Addendum #1 - Bid Package #6929-05

Project Name: Lincoln Public Schools District Office
5901 'O' Street
Lincoln, NE
Project No.: 11065
Issued: April 2, 2012

DEMOLITION & GRADING PHASING PLAN

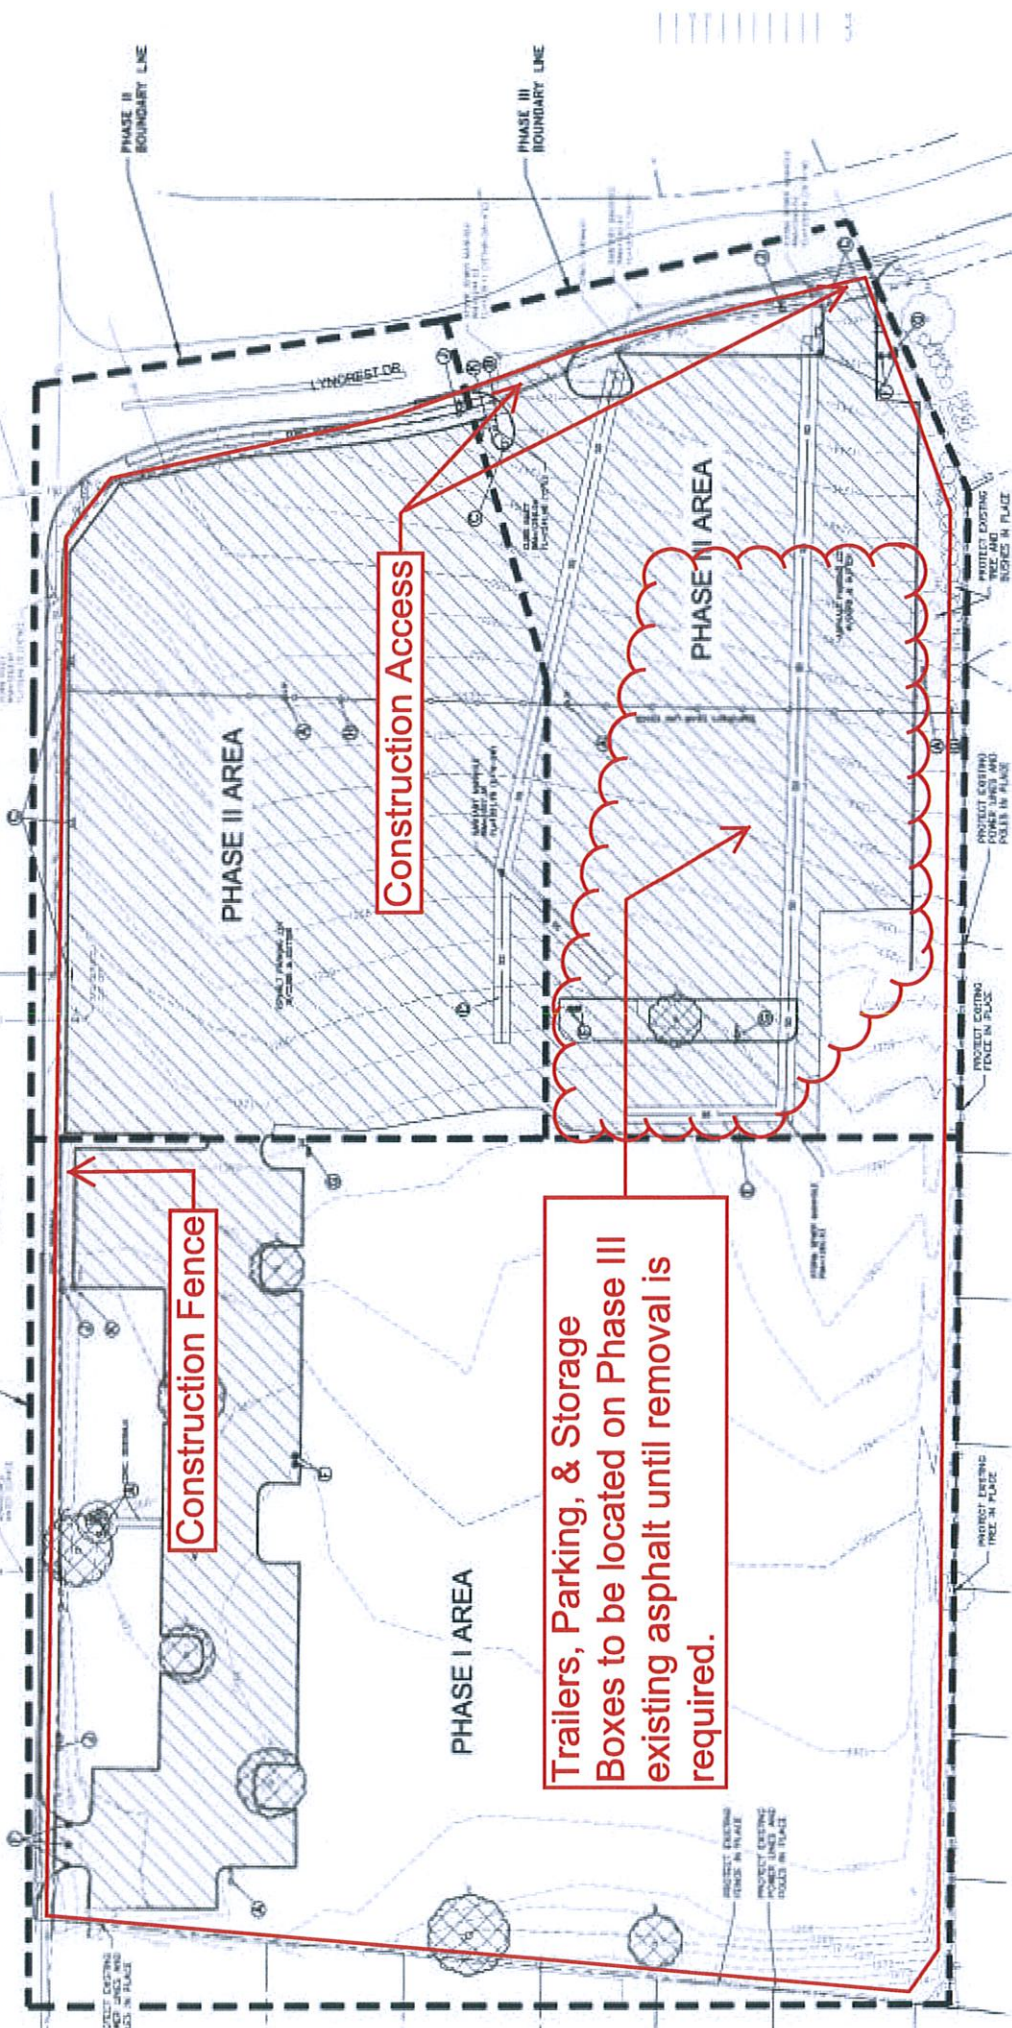
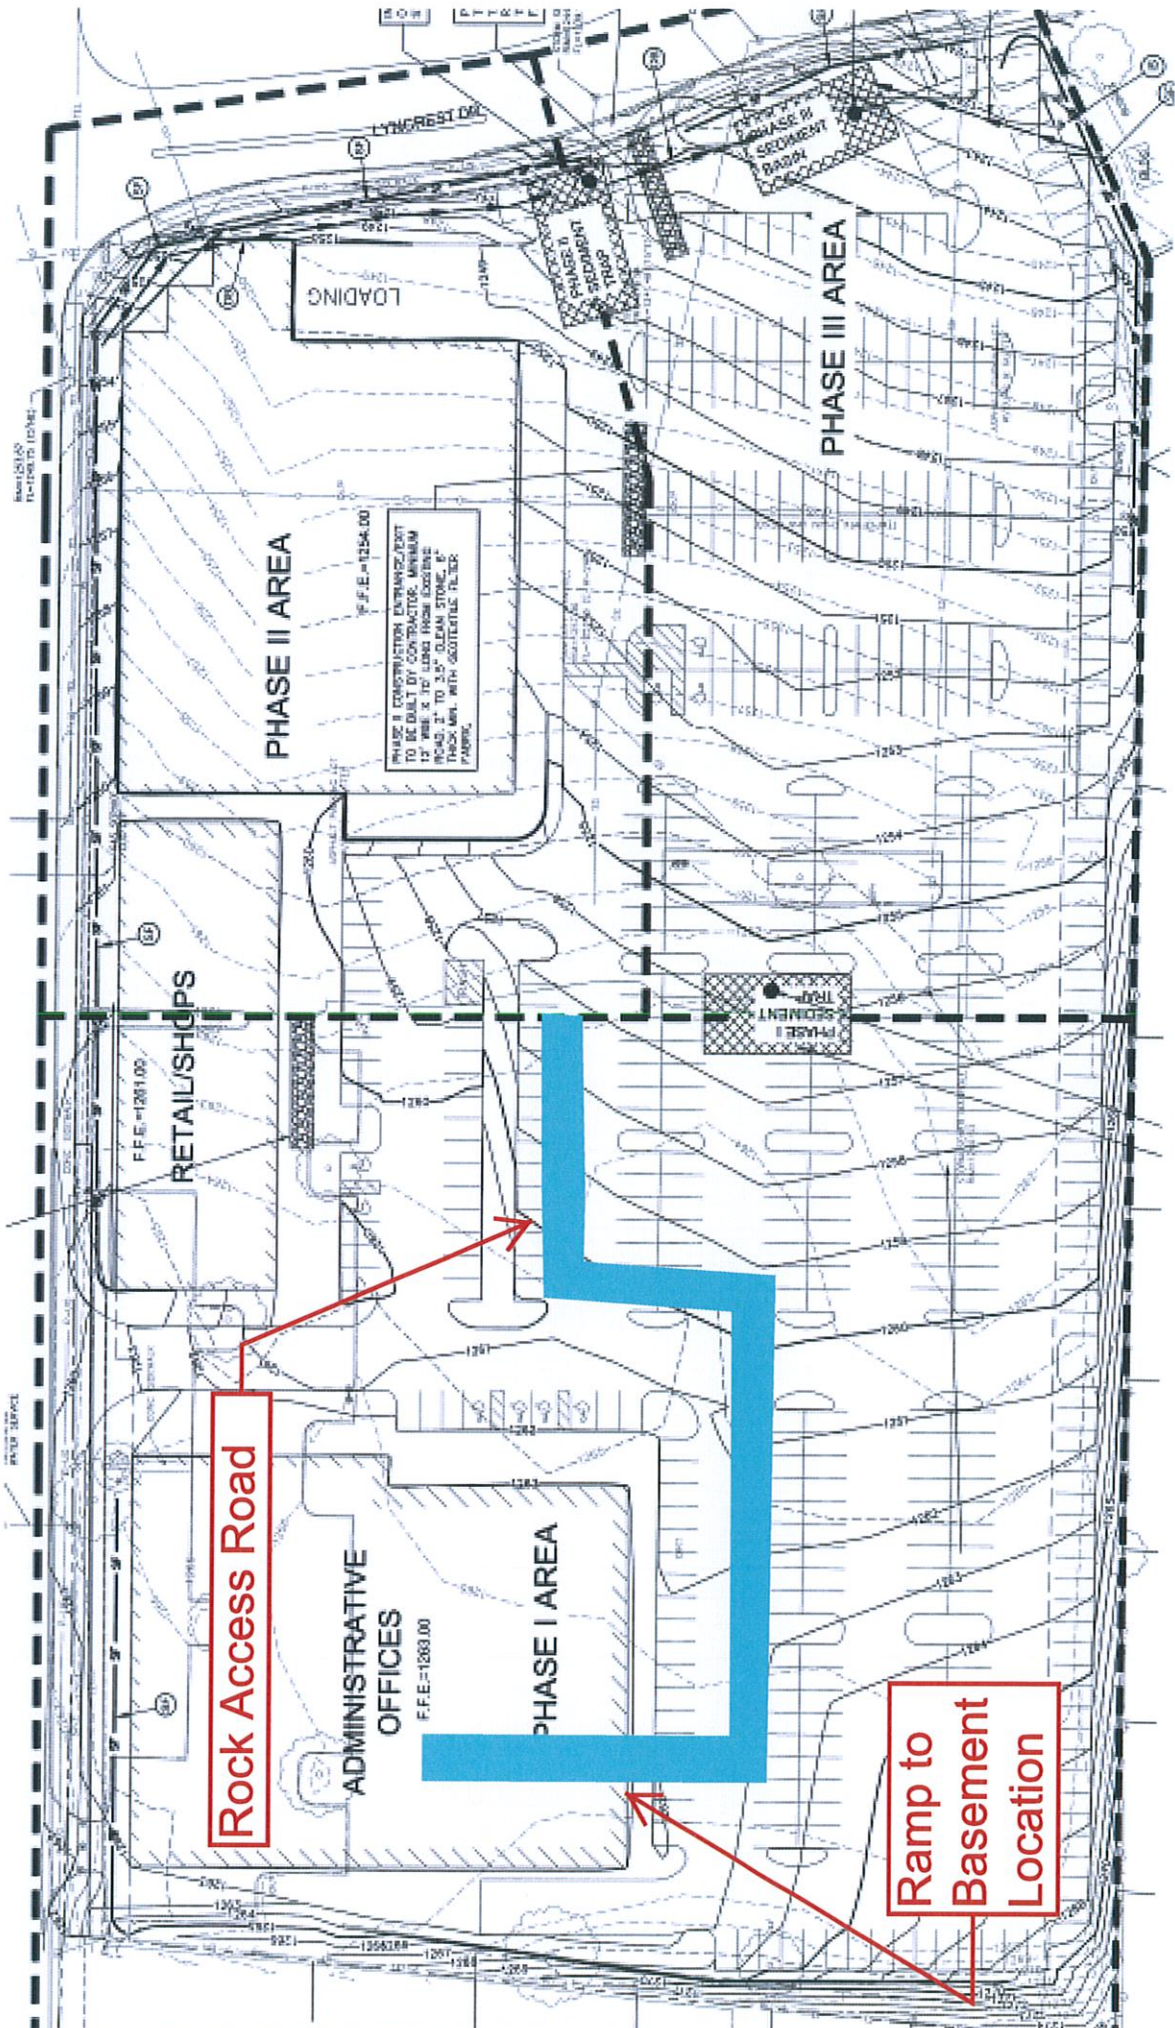
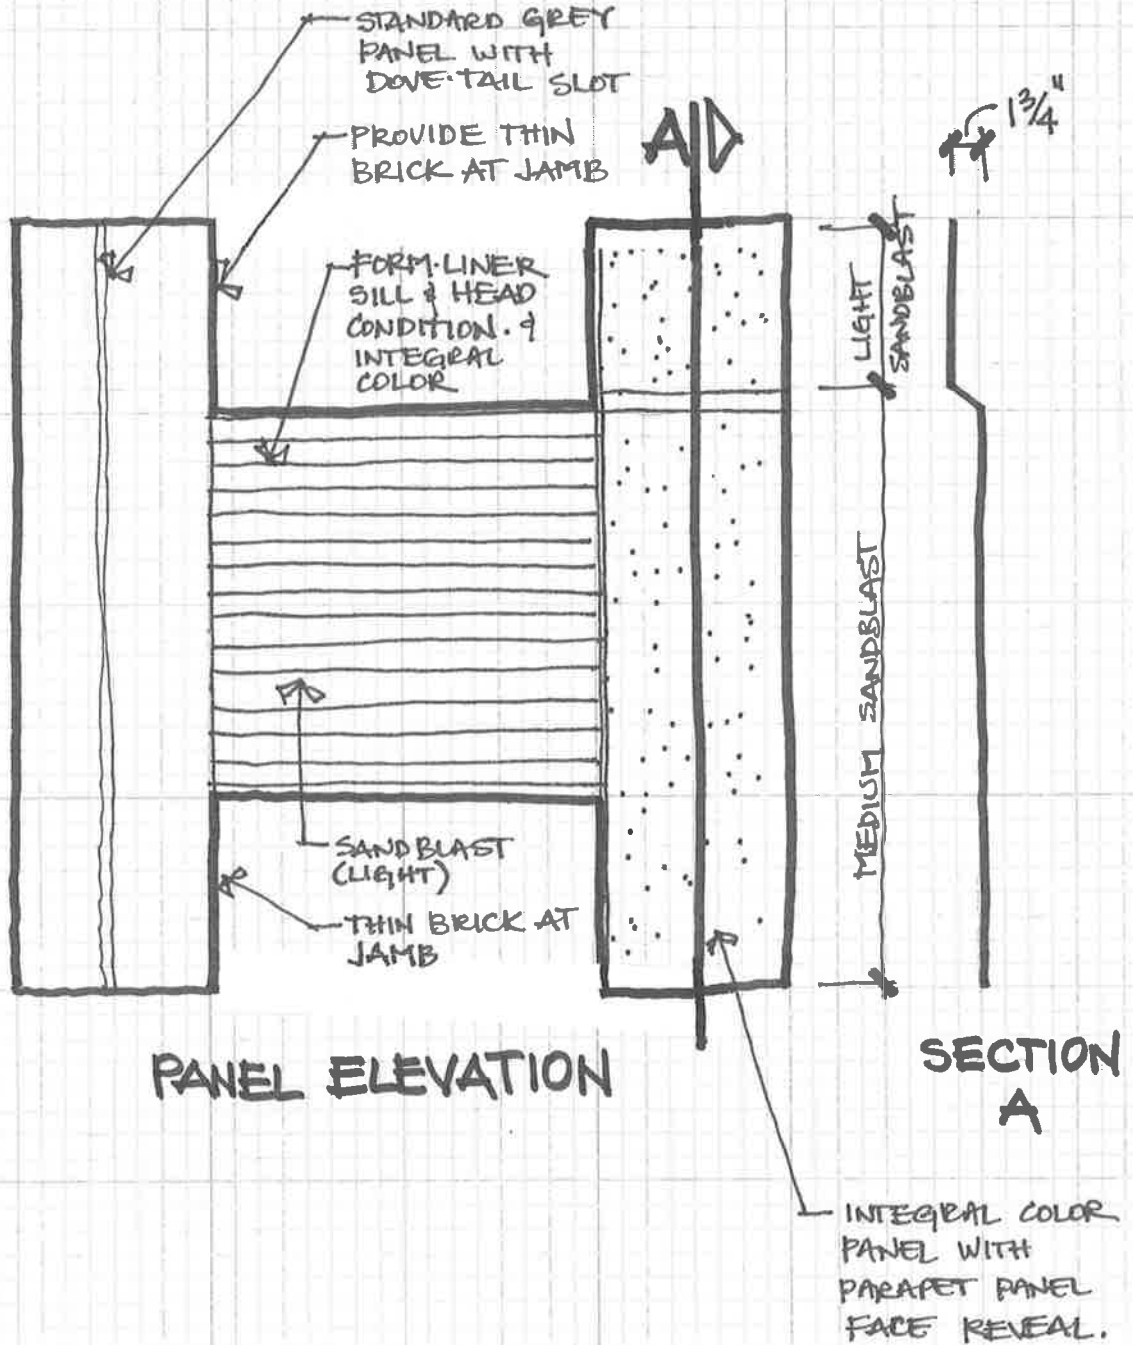
- ADD 1-3.** **Construction Phasing and Site use Plans** are included with this addendum.
- ADD 1-4.** **Testing** of connections is to be done by LPS.
- ADD 1-5.** **Geotechnical Report** is available to view online at www.adtechplans.com or sent via email from Tony Jarecki (TJarecki@hampton1.com) upon request.

PRECAST MOCK-UP PANEL

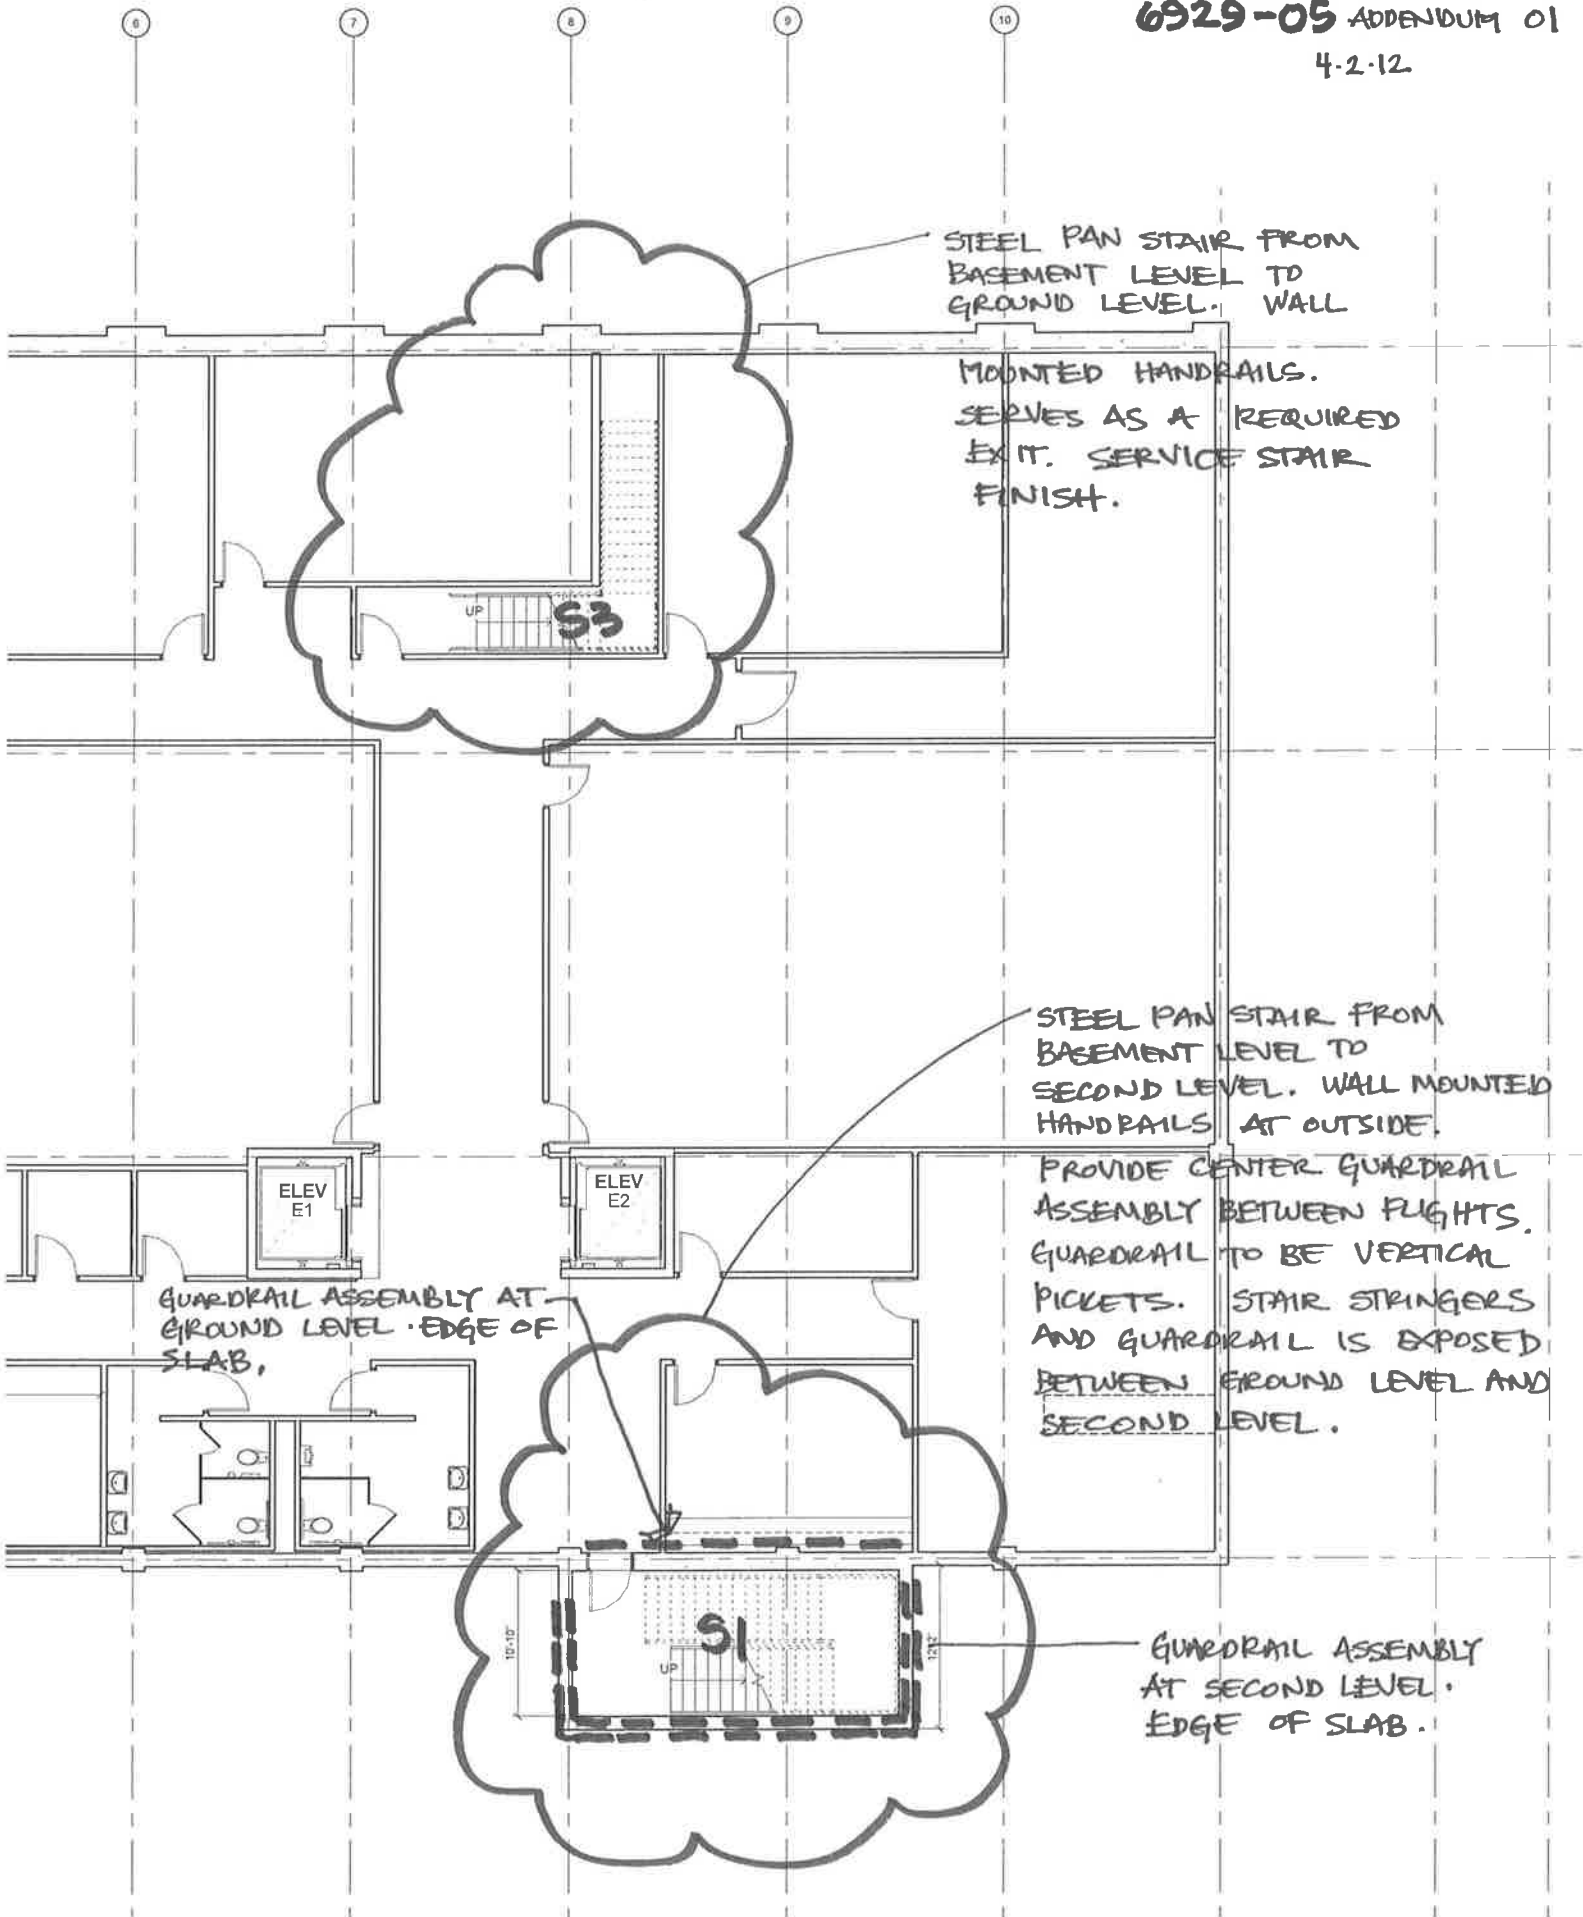
- 3. Provide mockup panel in configuration shown on drawing attached at the end of this section.

ADD 1-17. Refer to Section 034500 "Precast Architectural Concrete"; Add the **Precast Mockup Panel Sketch** included as part of this addendum to the end of the Precast section.
